Glenn Starr  
Ventus Energy

## **Taumatotara Wind Farm – Noise effects of change in turbine**

## 2 Review by Marshall Day Acoustics

Map Version 1.1C  
 Photo Ref: Aerial Surveys Ltd flown 10/03/18  
 Coordinates in NZMG (NZGD1949)  
 Cadastral Ref: LandOnline 02/11/19  
 Manawatu Aerial Photo Services RN 27/10/20

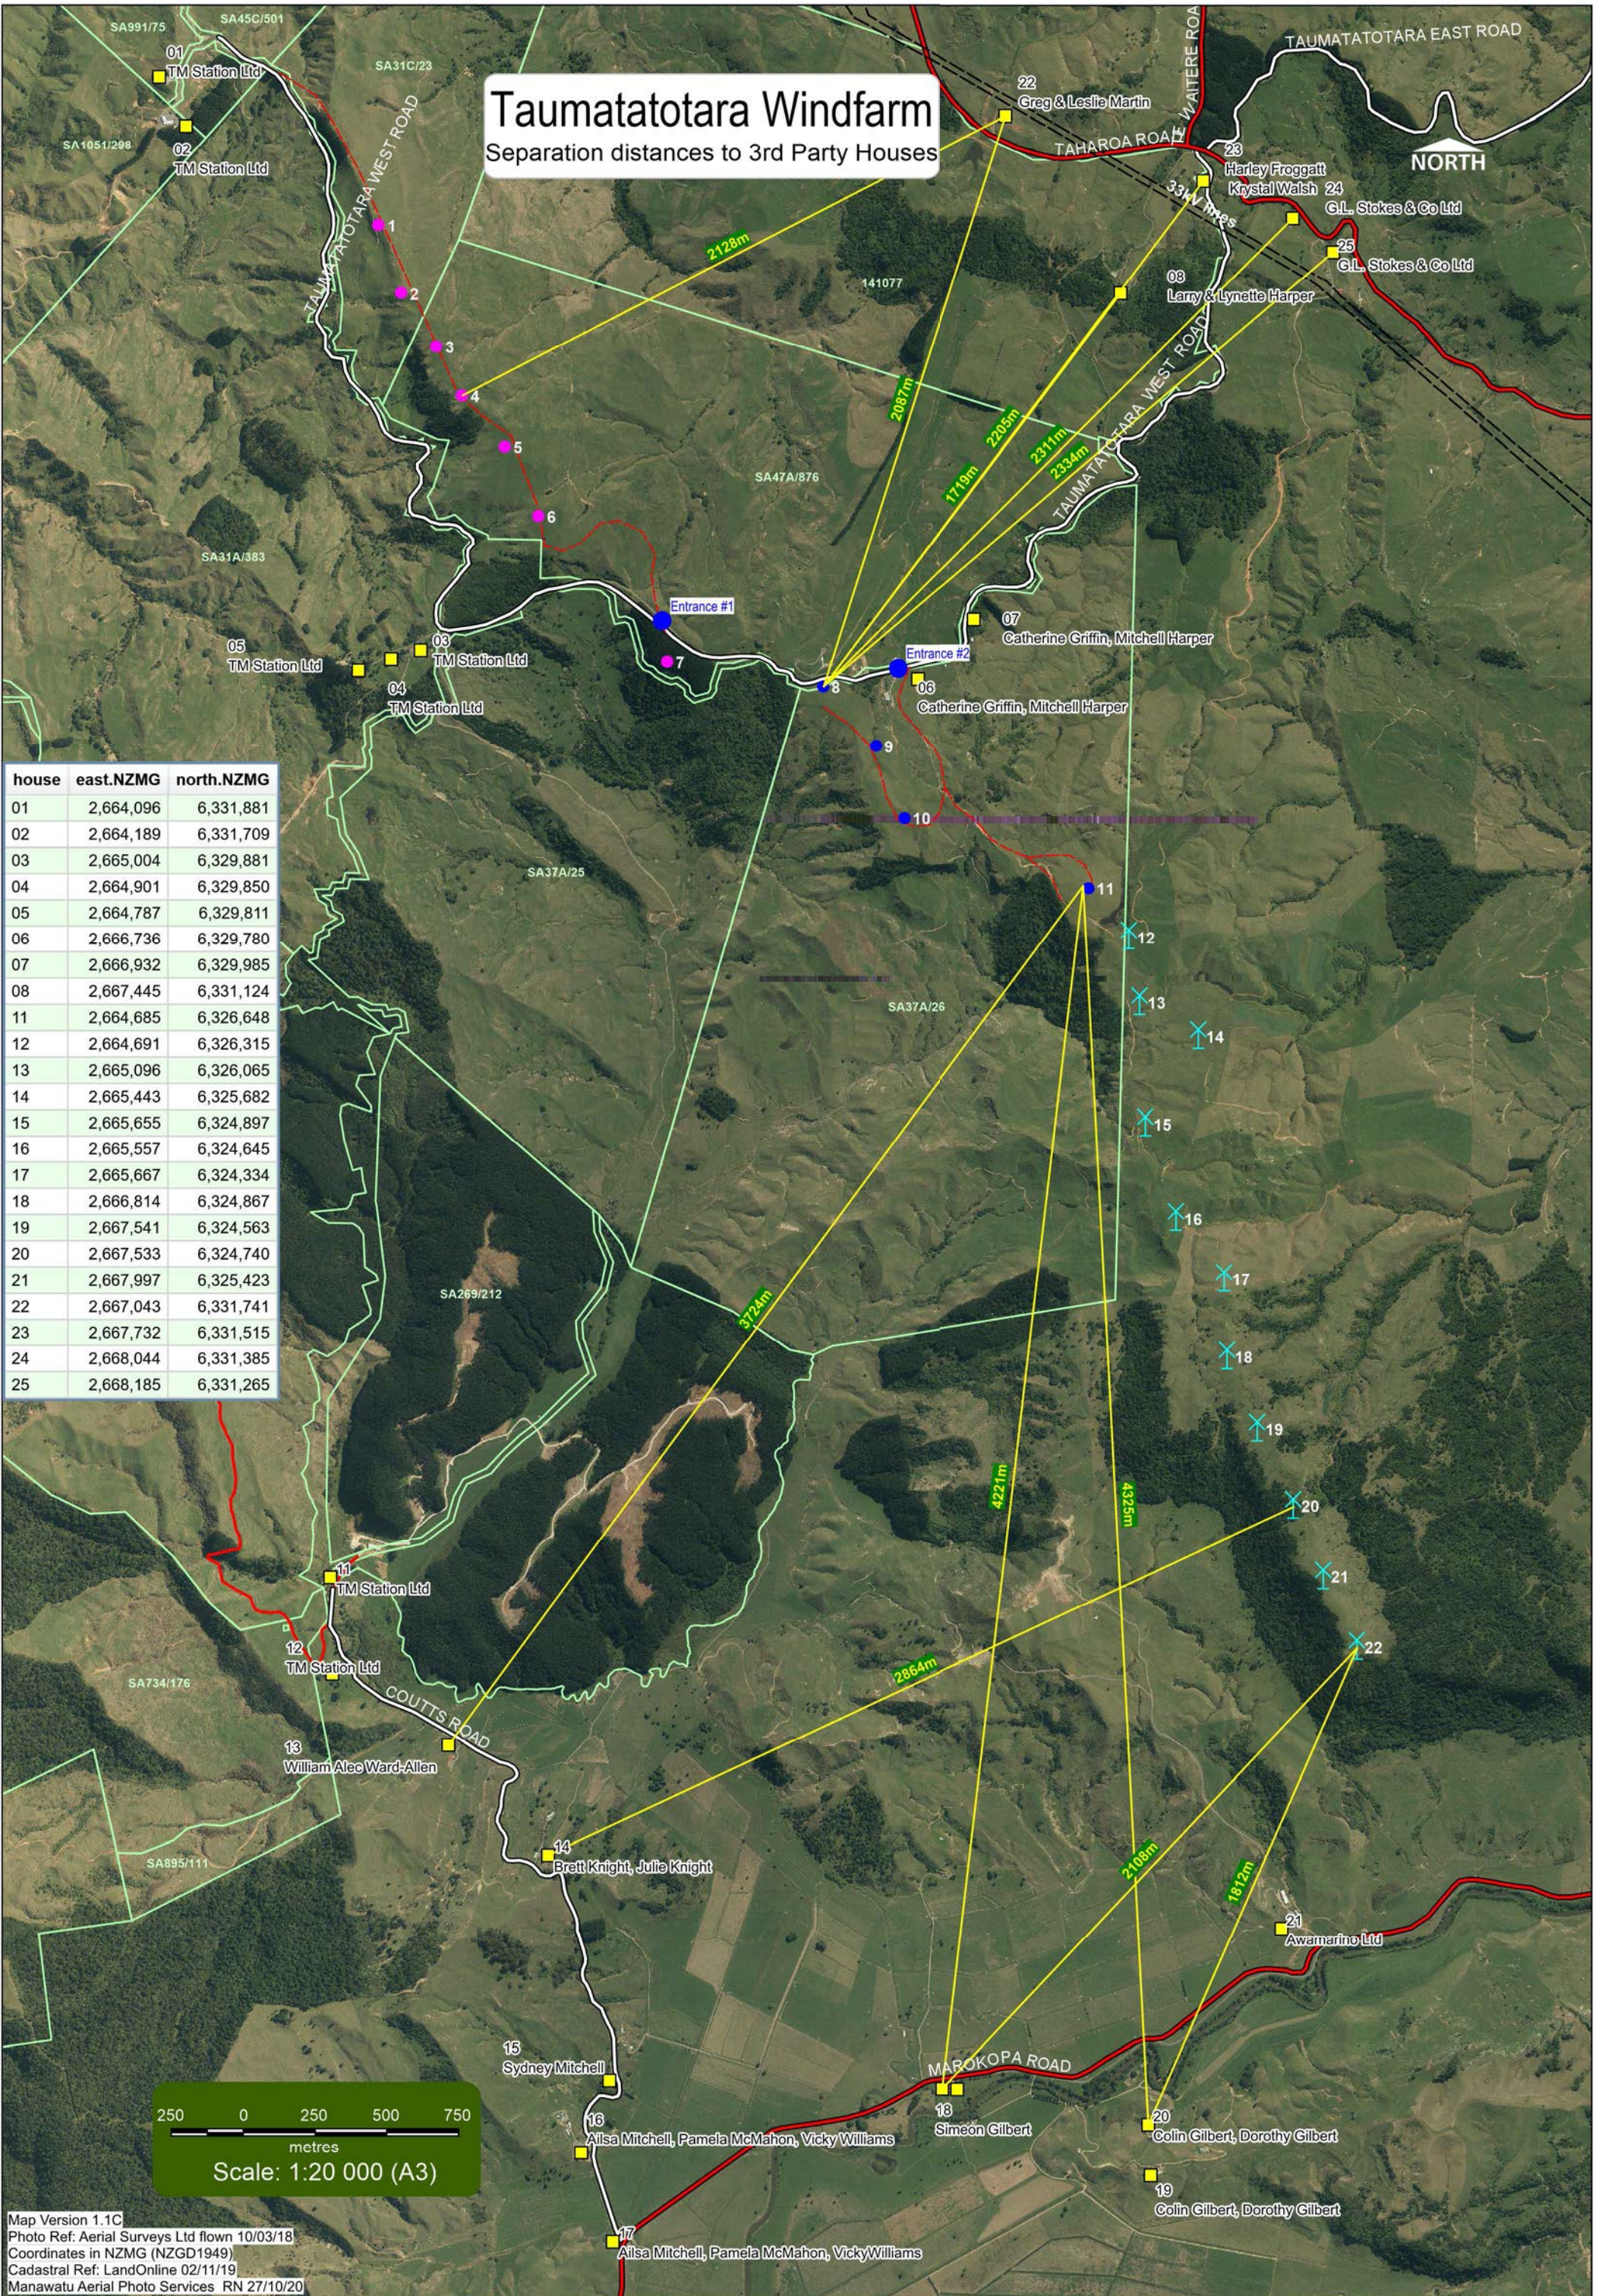
Item	Information requested	Response
3	At least one appropriately timed survey of sufficient duration should be undertaken to fulfil the requirements of NZS6808. This survey should be undertaken at one relevant receiver location following accurate predictions of noise levels at all relevant receivers (refer below). The receiver location should not be on the wind farm site. However, if a dwelling is outside the wind farm site but has provided written approval, this location may be a suitable measurement location.	<p>This request relates to issues with the original application.</p> <p>There is no proposal to alter the turbine locations, therefore no new receivers are affected.</p> <p><b>No additional information required</b></p>
4	The coordinates of all dwellings that are to be assessed (i.e. not on the wind farm site, or from which written approval has been obtained from the owner and occupier)	<p>Coordinates are included on the site plan v1.1c.</p> <p><b>We recommend that this plan is updated to clearly identify which positions noise limits apply to</b></p>

We note that the Martin property did not exist when the original consent was granted. Therefore, under Condition 8, noise limits would not apply at this location. Ventus Energy has agreed to include this property as an Assessment Position in the conditions in Table 2.

No	Operative condition	Suggested update
7	<p>The noise from all other activities on the site (other than wind turbine generator operation and construction activities) shall not exceed the following limits when measured in accordance with the requirements of NZS 6801:1991 Measurement of Sound and assessed in accordance with NZS 6802:1991 Assessment of Environmental Sound:</p> <p>7.00am to 7.00pm      45 dBA L<sub>10</sub>  7.00pm to 7.00pm      35 dBA L<sub>10</sub>     60 dBA L<sub>max</sub></p>	<p>The consent holder shall ensure that sound from sources on the site other than those within the scope of conditions 8 and 12 does not exceed the following noise limits:</p> <p>7.00am to 7.00pm    45 dB L<sub>Aeq(15min)</sub>  7.00pm to 7.00pm    35 dB L<sub>Aeq(15min)</sub>     60 dB L<sub>AFmax</sub></p> <p>Sound shall be measured in accordance with NZS 6801:2008 and assessed in accordance with NZS 6802:2008.</p> <p>The assessment positions shall be at the noise sensitive locations shown on Site Plan 1.1c attached.</p>
